REMARKS

Thomson Multimedia Licensing Inc.
Patent Operations
CN Box 5312
Princeton, NJ 08543-5312

FIG. 2A

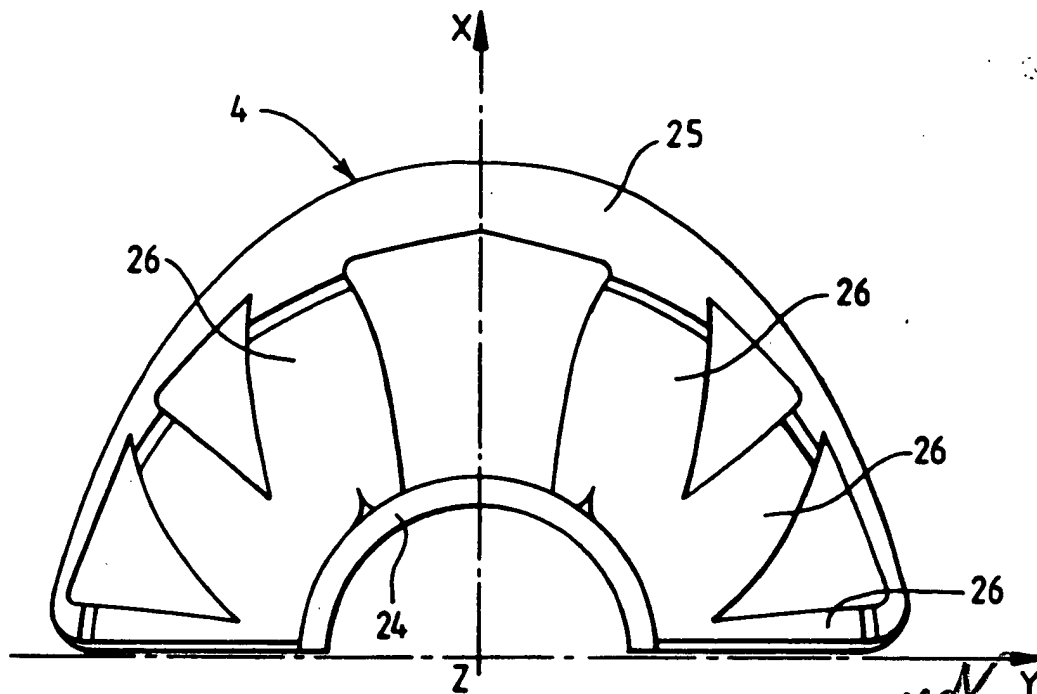
The drawing Figure 2A and 2B and the Specification have been amended, in accordance with the Examiner's requests. The Abstract has been substituted, in accordance with the Examiner's request.

PRIOR ART

*Approved
gy 7/03/02*
